August 29, 2016

Re: The Lodges-- IWA Application W1564
Response to August 12, 2016 Memo

THE LODGES AT STORRS

IW-1

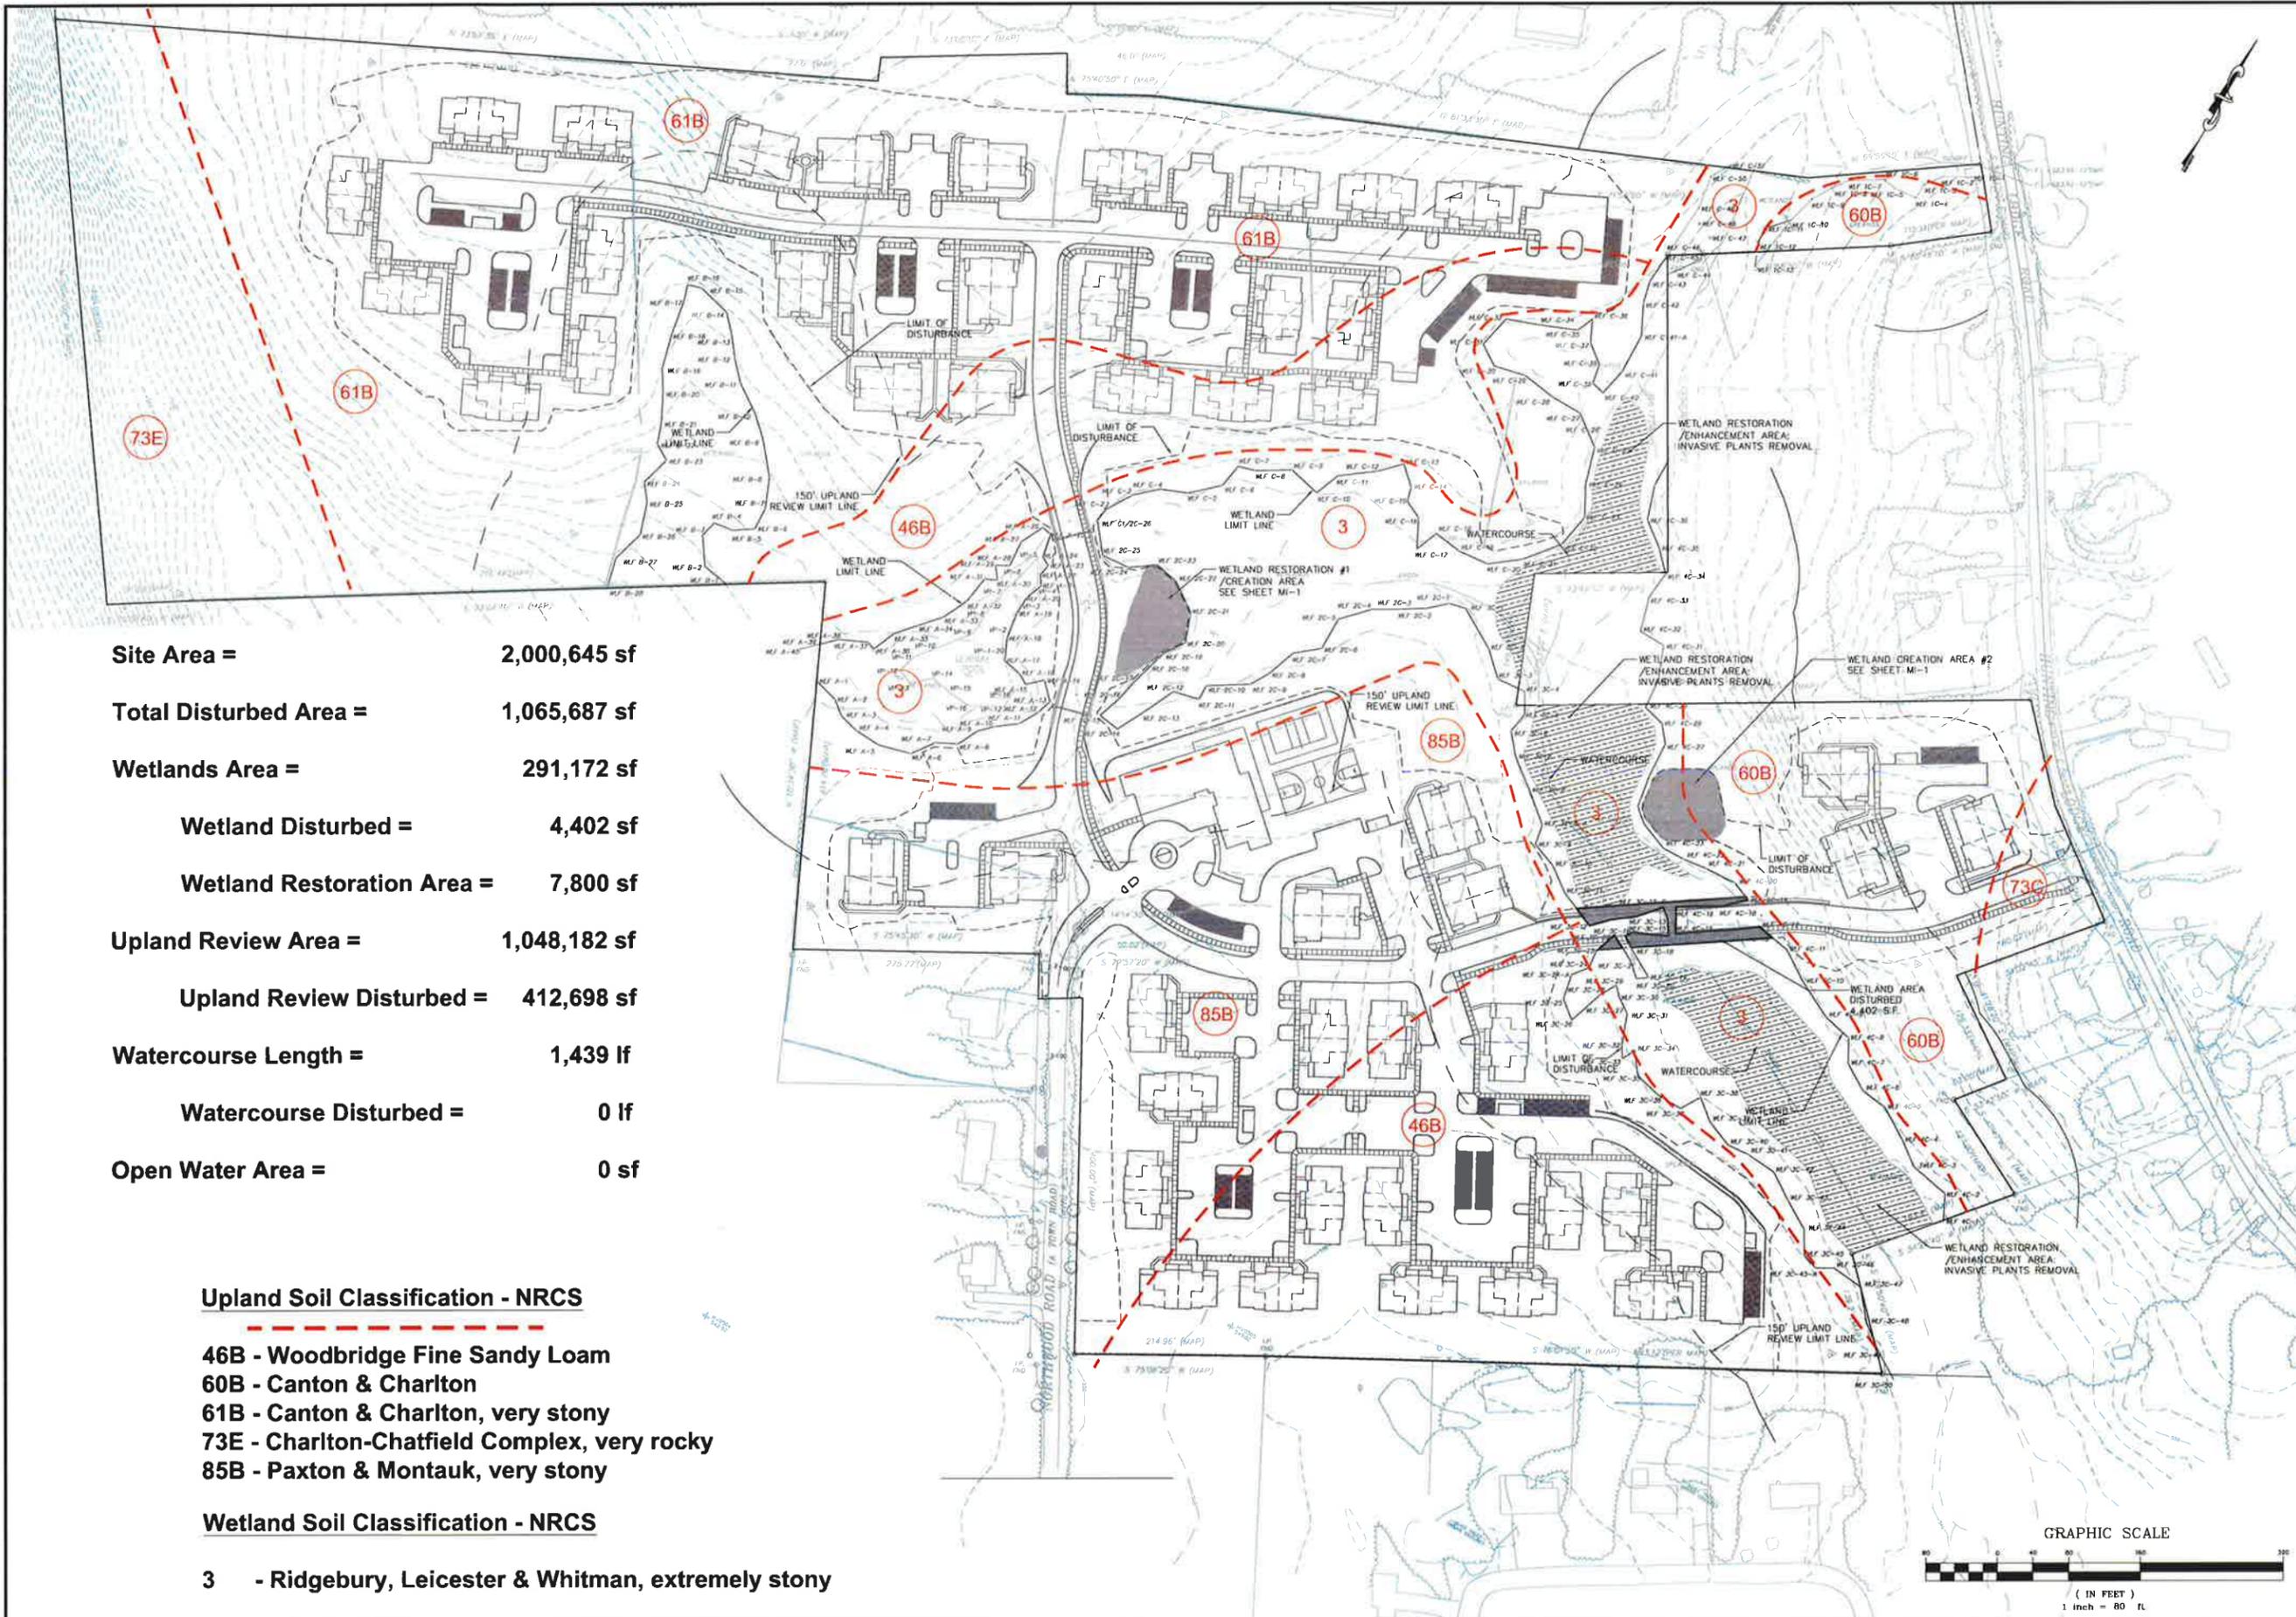
The memo raises a number of questions regarding the soil types found on the property and how they have been depicted on the application plan set. Reference is made to Sheet IW-1, the NRCS soils map and a 2007 soils report prepared by John P. Ianni, a certified soil scientist, who previously provided consulting services for the project. Regarding Sheet IW-1, in accordance with the required application items listed in the town wetland regulations, the upland soil types were included on this plan based on an interpretation of the NRCS map and the limits of wetland soils were shown taken from the defined limits included on the recently approved official wetlands map for the property. In order to clear up any confusion on this issue, we have revised Sheet IW-1 to more clearly define the soil type boundaries and have also added the wetland soil types to the soil classification table listed on the plan (see attached Sheet IW-1, revised 8/30/16).

It is widely understood that the USDA-NRCS Soil Survey maps are a coarse-scale representation of soil mapping units in the landscape, with an emphasis on agricultural uses. NRCS soil scientists would map hundreds of acres per day. While the soil survey maps are valuable for planning purposes, they are not accurate enough for final site design. That is why the project team's soil scientist accurately delineated the limits of poorly and very poorly drained soils on the property, which were then surveyed and plotted on the plans. This is also the reason why project team members, including the soil scientist of record, Mr. George Logan, inspected the upland soils within the development envelope, and found them to be generally consistent with the types of soils identified in the NRCS soil survey, even though the limits of the soil series may differ considerably in the field as compared to those seen on the less accurate NRCS soil survey map.

It must be noted that the limits of the different types of soils are a matter of some interpretation since it is not possible to directly translate the limits depicted on the NRCS map, or other similar reference source mapping, to the plan set due to a lack of common mapping scale, loss of

accuracy because of previous reproduction/reprographics inconsistencies and recognition of obvious topographical features found on a specific property that affect the drawing of the limits on the plan. Site planners often refer to the NRCS map and other available soil reference materials as tools during the undertaking of an initial general analysis of soil characteristics in concert with the start of the preliminary planning phase for a given site and generally do not do any type of detailed calculations or final site design based heavily on this data. The only soil types on the property that have been defined precisely are the limits of wetland soils shown which were flagged in the field by the soil scientist and located by the project land surveyors.

No.	Date	Description
1	08-10-2016	Town comments
2	08-30-2016	Add Wetland Soil Types
